Well Name: POKER LAKE UNIT 23 DTD FED STATE COM	Well Location: T24S / R30E / SEC 23 / NENW / 32.209704 / -103.852609	County or Parish/State: EDDY / NM
Well Number: 175H	Type of Well: CONVENTIONAL GAS WELL	Allottee or Tribe Name:
Lease Number: NMNM030452	Unit or CA Name: POKER LAKE UNIT	Unit or CA Number: NMNM71016X
US Well Number: 3001549651	Operator: XTO PERMIAN OPERATING LLC

Notice of Intent

Type of Action: APD Change

Procedure Description: Effective date 9/1/22 XTO Permian Operating LLC respectfully requests to make the following changes: Dedicated acres: f/ 1920.66 t/2080.66 Name change: f/ POKER LAKE UNIT 23 DTD FED STATE COM 175H t/ POKER LAKE UNIT 23 DTD FED COM 175H TD: f/ 27541' MD / 11270' TVD t/ 27362' MD/ 11282.8' TVD FTP: f/ 100' FSL 1870' FEL t/ 198' FNL 1870' FEL Sec 23, 24S 30E; Lease NMNM0030452 Updated HSU Attachments: Updated C-102 on new form, drilling plan and directional survey

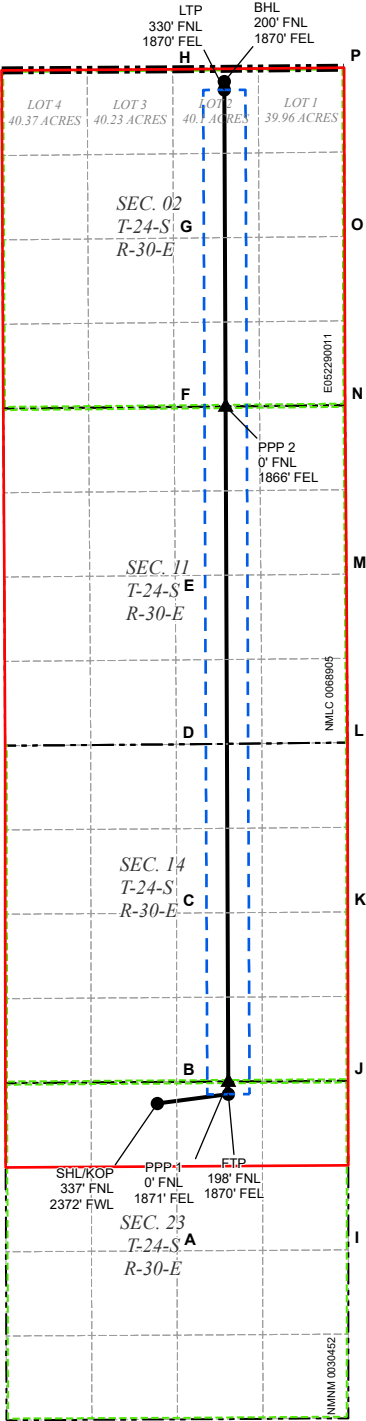
Dedicated acres: f/ 1920.66 t/2080.66

FTP: f/ 100 FSL 1870 FEL t/ 198 FNL 1870 FEL Sec 23, 24S 30E; Lease NMNM0030452

Dedicated Acres 2,080.66	Infill or Defining Well INFILL	Defining Well API 30-015-49652	Overlapping Spacing Unit (Y/N) N	Consolidation Code P
Order Numbers: R-23810			Well setbacks are under Common Ownership: ☒ Yes ☐ No

UL	Section	Township	Range	Lot	Ft. from N/S	Ft. from E/W	Latitude	Longitude	County
B	23	24S	30E		198 FNL	1,870 FEL	32.210090	-103.849016	EDDY
